RESPONSE TO SUBMISSIONS REPORT
**Proposed Longwalls 51 & 52
West Wallsend Colliery**

RESPONSE TO SUBMISSIONS REPORT

Prepared by
Umwelt (Australia) Pty Limited
on behalf of
Oceanic Coal Australia Pty Limited

Project Director: John Merrell
Project Manager: Luke Bettridge
Report No. 3149/R04/FINAL
Date: June 2014

FIGURE 2.1
LMCC Subdivision

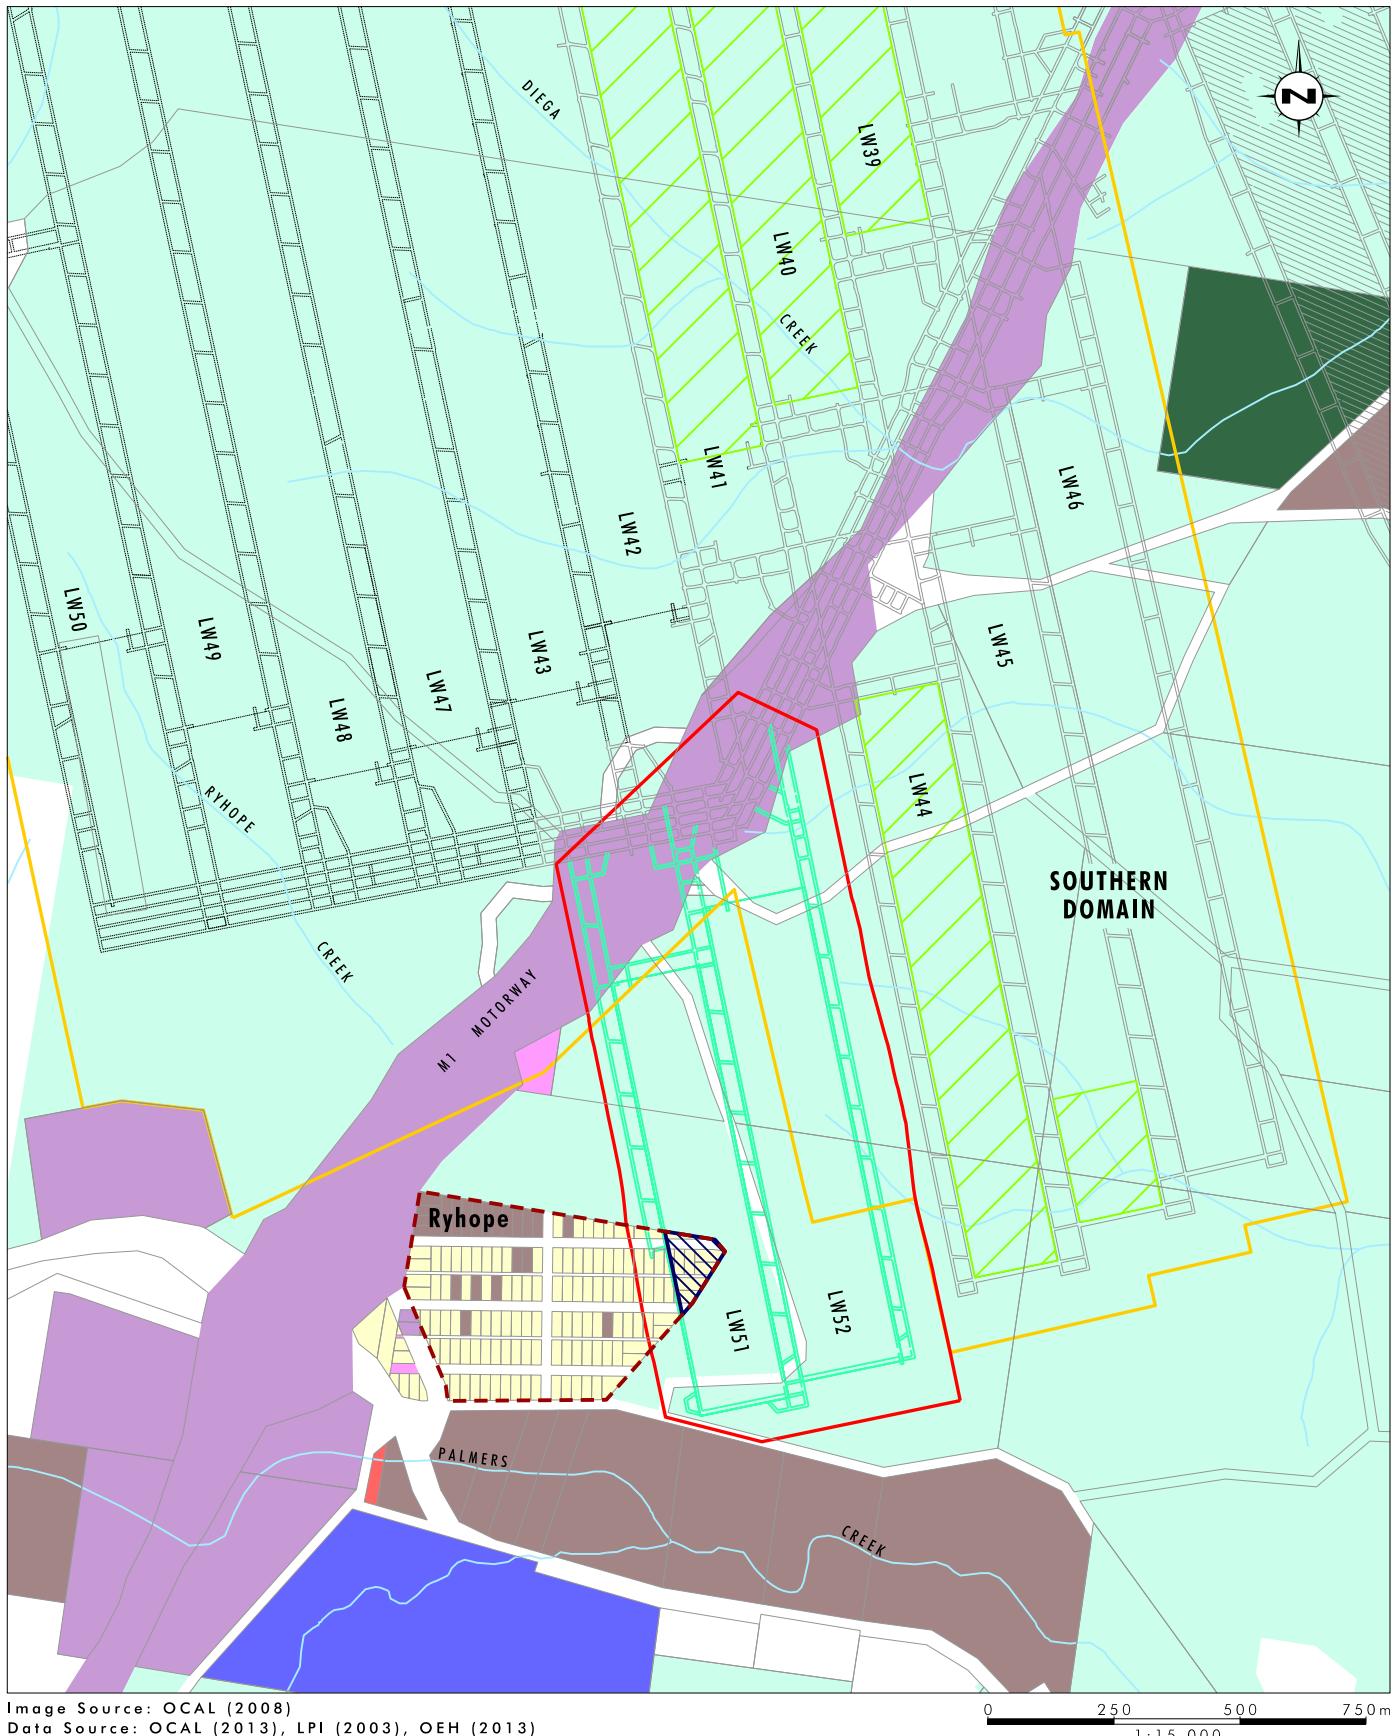
I object to any subsidence that may occur on a biodiversity offset site. However, if the proposal is approved then the following should be considered:

- That any subsidence is made safe and any natural areas are rehabilitated or compensated by a biodiversity offset. If another biodiversity offset is required then this offset has to consider that the natural land contained within the Ryhope Estate had already been used as an offset and therefore any biodiversity offset would need to be doubled.**

OCAL identified early in consultation about the Project that LMCC was considering the potential of this area as a future biodiversity offset. As indicated on **Figure 2.1**, OCAL understands that LMCC is considering all of its land holding as a biodiversity offset, being an area of approximately 18.8 hectares. Approximately 1.04 hectares of this proposed offset is proposed to be undermined by the Project. This issue was specifically addressed in OCALs meeting with LMCC on 24 May 2013 and OCAL assumes that LMCC will, in finalising its approach to this potential offset, take into account the presence of a mining lease that covers this area. It is noted that no biodiversity offset currently exists at this site. Regardless, as OCAL has outlined in the EA and in consultation with LMCC, OCAL considers that a biodiversity offset in the area and underground mining would be compatible.

OCAL identified early during consultation about the Project that LMCC was considering the potential of this area as a future biodiversity offset. As indicated on **Figure 2.1**, OCAL understands that LMCC is considering all of its land holding as a biodiversity offset, being an area of approximately 18.8 hectares. Approximately 1.04 hectares of this proposed offset is proposed to be undermined by the Project. This issue was specifically addressed in OCALs meeting with LMCC on 24 May 2013 and OCAL assumes that LMCC will, in finalising its approach to this potential offset, take into account the presence of a mining lease that covers this area. It is noted that no biodiversity offset currently exists at this site. Regardless, as OCAL has outlined in the EA and in consultation with LMCC, OCAL considers that a biodiversity offset in the area and underground mining would be compatible.

FIGURE 2.2

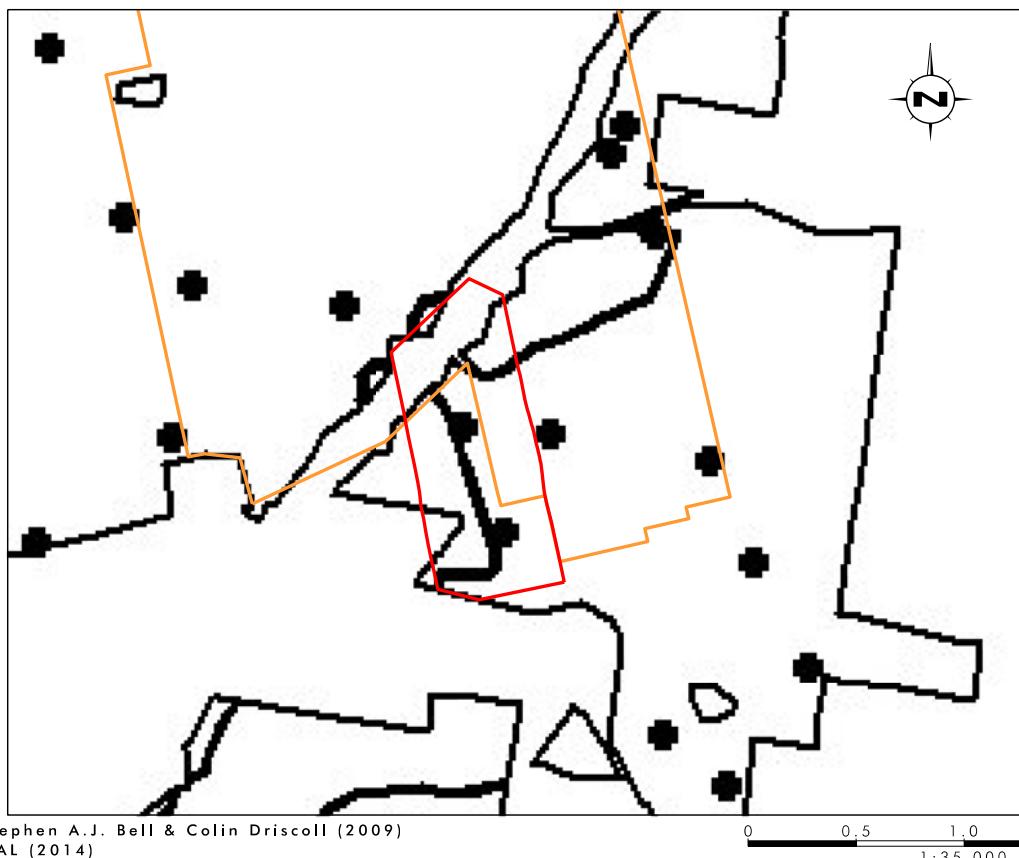
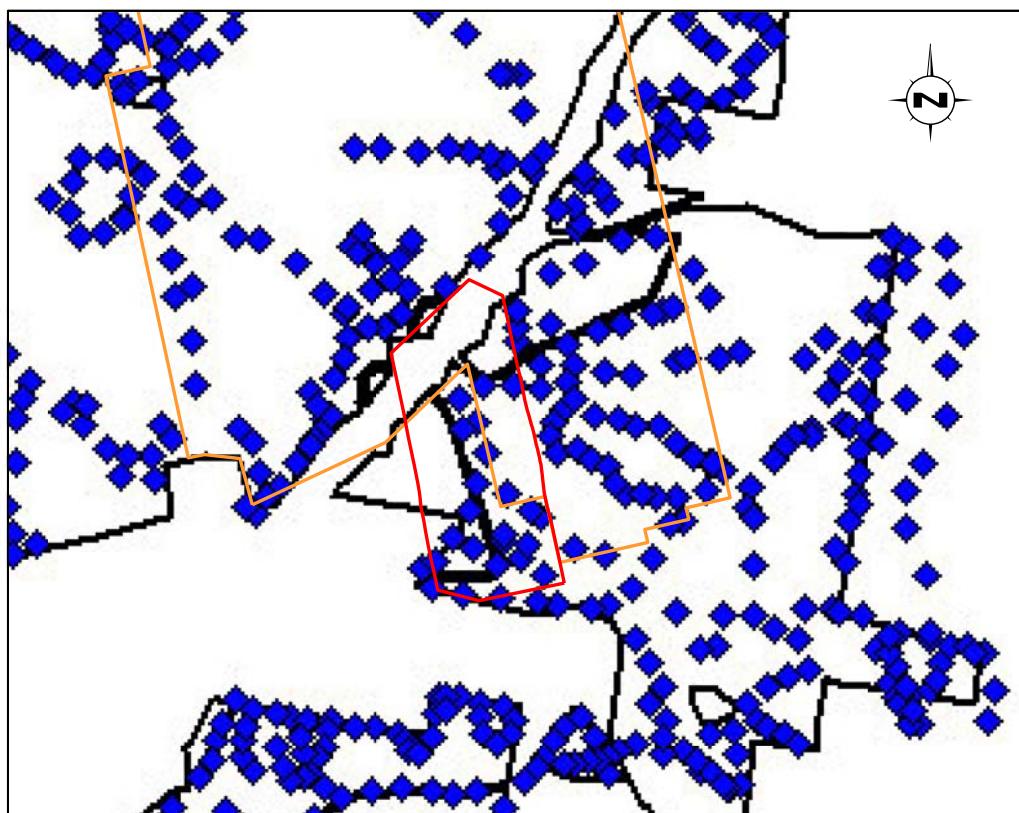
OEH recommends that appropriate surveying in accordance with accepted guidelines be undertaken in these areas, unless other data sources are provided. OEH notes that Section 3.4 (Summary and Adequacy of Flora Field Survey Effort) of Appendix 5 states that the mapping conducted by Bell and Driscoll (2009) of Sugarloaf SCA was used given its accuracy, but fails indicate if survey sites undertaken for this mapping fall within the Project Area (i.e. quadrats) and whether they were used to verify the vegetation communities.

OEH suggests that the proponent provide a table that details sampling methods and survey effort per stratification unit, including size of each unit, timing of surveys (not just the survey, but each specific component), prevailing climatic conditions at time of survey, and how they meet the minimum requirements in OEH survey guidelines (DEC, 2004). A map overlaying the survey details over the stratification units I vegetation types must also be included in any future versions of the EA.

Figure 2.2 shows the extent of survey effort undertaken by Bell and Driscoll (2009) for the SSCA mapping project. **Figure 2.3** shows the extent of Umwelt flora surveys in the project area in relation to native vegetation communities; and also shows the location of sampling locations undertaken for the West Wallsend Colliery Continued Operations Project (WWCCOP) Environmental Assessment (Umwelt 2010c) and the annual West Wallsend Biodiversity Monitoring program. All of these surveys and assessment were considered in the preparation of the Ecological Assessment for the Project and the results of the flora assessment and vegetation mapping are therefore considered to be robust and applicable at the scale of the assessment, and therefore are adequate for the purpose.
